- Request - Special Use Permit for a tobacco shop
- Location - 1501 S. Detroit Avenue
- Applicant/Owner - Msalim Properties, Inc.
1501 S. Detroit Avenue
Toledo, OH 43614
- Engineer - Pro Architect, LLC
20824 Whitlock Drive
Dearborn Heights, MI 48127

The staff recommends that the Toledo City Plan Commission recommend **disapproval** of SUP-7007-24, a request for a Special Use Permit for a tobacco shop at 1501 S. Detroit Avenue, to Toledo City Council for the following reason:

SPECIAL USE PERMIT
TOLEDO CITY PLAN COMMISSION
REF: SUP-7007-24
DATE: March 13, 2025
TIME: 2:00 P.M.

SITE PLAN

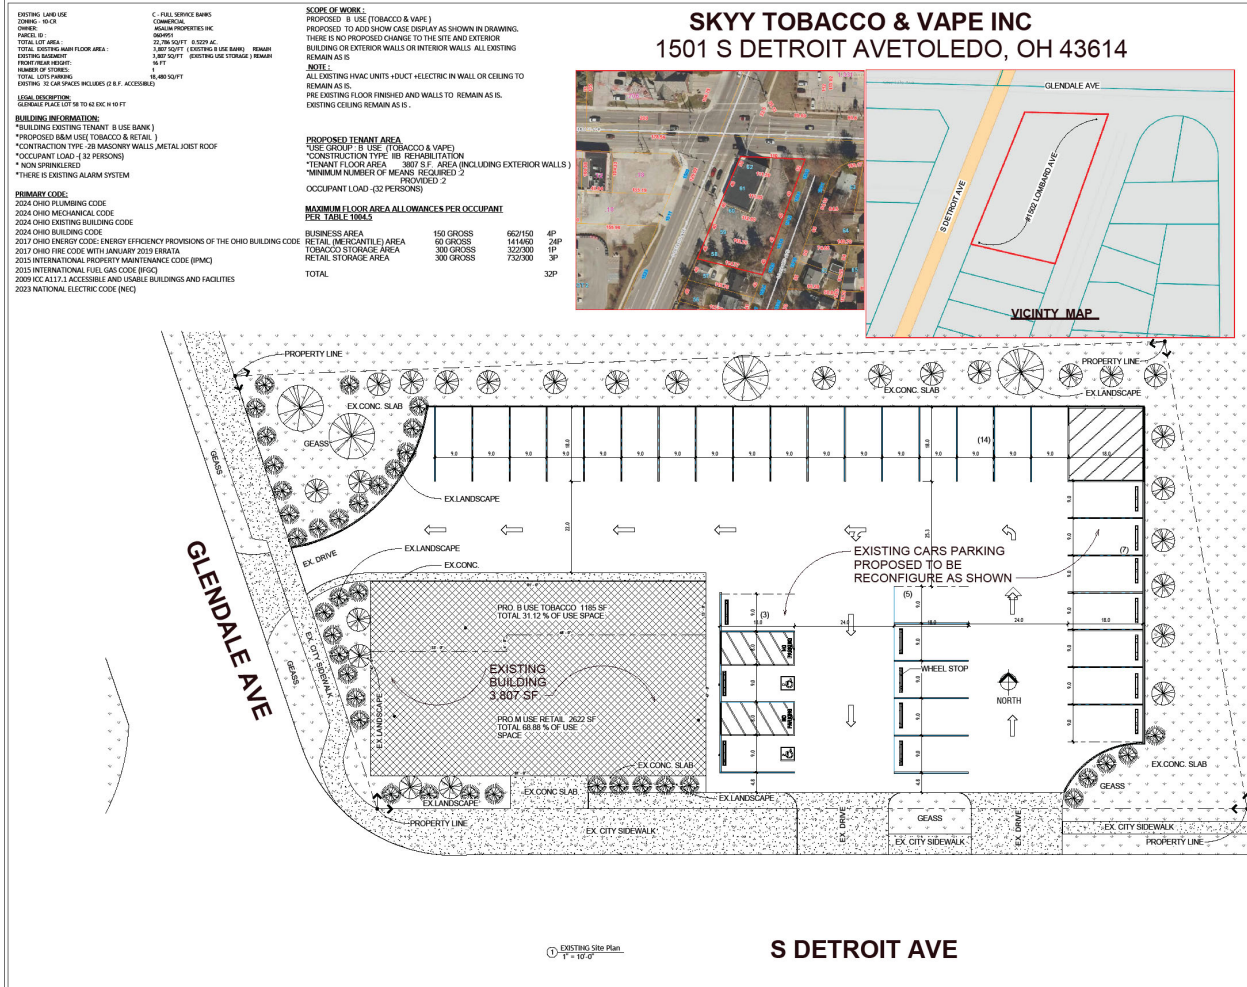
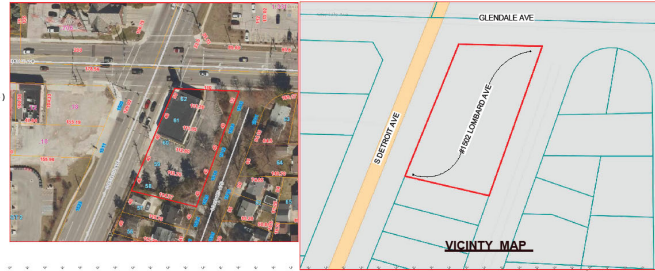
Currently there are three (3) access points to site. One from Glendale Avenue and two (2) from Detroit Avenue. As depicted on the site plan, only one access point will be for ingress to the site. This is the drive along Detroit Avenue furthest from the intersection of Glendale and Detroit Avenues. The other access point of Detroit Avenue and the access point on Glendale Avenue are depicted as egress only. Per comments received from the Division of Transportation, they are requesting that the access on Detroit Avenue, closest to the intersection of Detroit and Glendale be closed. In addition, they are requesting that the Glendale Avenue access be made as ingress only. These comments are listed as conditions of approval.

- Per the Off-Street Parking Schedule in TMC§1107.0304 commercial use buildings are required to provide one (1) parking space per 300 square feet of floor area. The building consists of 3,807 square feet, which requires thirteen (13) required parking spaces. The site plan depicts in excess of the required parking spaces and therefore complies with this requirement.

- In addition, one (1) bicycle parking space is required for every 10 parking spaces. The site plan depicts thirty-one (31) parking spaces, which requires four (4) bicycle parking space. There is no bicycle parking depicted on the site plan; therefore, the proposal does not comply with this requirement. Bicycle parking shall be provided as a condition of approval.

- Per TMC§1107.1701, one (1) auto accessible and one (1) van accessible parking space is required for the parking lot based on the number of parking spaces. The site plan depicts two (2) van accessible parking spaces. The proposal therefore complies with this requirement.

- Per TMC§1107.1907 whenever a parking lot extends to a property line, sidewalk, planting strip, or building, a wheel stop device consisting of a concrete stop, a permanent concrete curb, an expanded sidewalk or other suitable restraint as approved by the Planning Director must be installed. There are wheel stops depicted on the site plan on all parking spaces except those along the east side of the parking lot. Wheel stops shall be provided for the parking spaces along the east side of the site as a condition of approval.

The Applicant is not proposing any changes to the existing landscape on the site. The site plan depicts what is noted as existing landscape. TMC§1114.0500 requires an existing site to be brought closer into compliance with the 2004 Zoning Code. Through a site visit, staff has noted that the majority of the existing plant material is overgrown and beyond its useful life or unable to be trimmed/pruned and still be viable. In addition, the site plan does not identify or accurately depict the plant material on the site. Staff recommends that the following be required as a condition of approval:

19. Per Off-Street Parking Schedule in TMC§1107.0304 one (1) bicycle parking slot is required per ten (10) parking spaces; or per TMC§1107.0901(B). A total of four (4) bicycle slots are required for this site. There are not bicycle parking slots depicted on the site plan. **Not acceptable as depicted. Four (4) bicycle slots shall be provided and shown on a revised site plan.**

21. Per TMC§1107.1907 whenever a parking lot extends to a property line, sidewalk, planting strip, or building, a wheel stop device consisting of a concrete stop, a permanent concrete curb, an expanded sidewalk or other suitable restraint as approved by the Planning Director must be installed. The site plan depicts wheel stops for all parking spaces except for the parking spaces along the east side of the parking lot. **Not acceptable as depicted. Wheel stops shall be provided for the parking spaces along the east side of the site and shown on a revised site plan.**

- a. The existing guardrail along the east and south property lines shall be removed.
 - b. All overgrown plant material and weeds shall be removed. Any viable shrubs in front of the building along Glendale and Detroit Avenues shall be trimmed. Supplemental plant material shall be provided to enhance the remaining plant material and to meet the required foundation plantings along Glendale and Detroit Avenues per TMC§1108.0205.

- c. The existing fence along the south edge of the parking lot shall be replaced.
 - d. A landscape buffer shall be provided along the east property line that includes one (1) tree per thirty (30) linear feet and a solid/continuous evergreen hedge to screen the parking area from the adjacent right-of-way and residential uses.
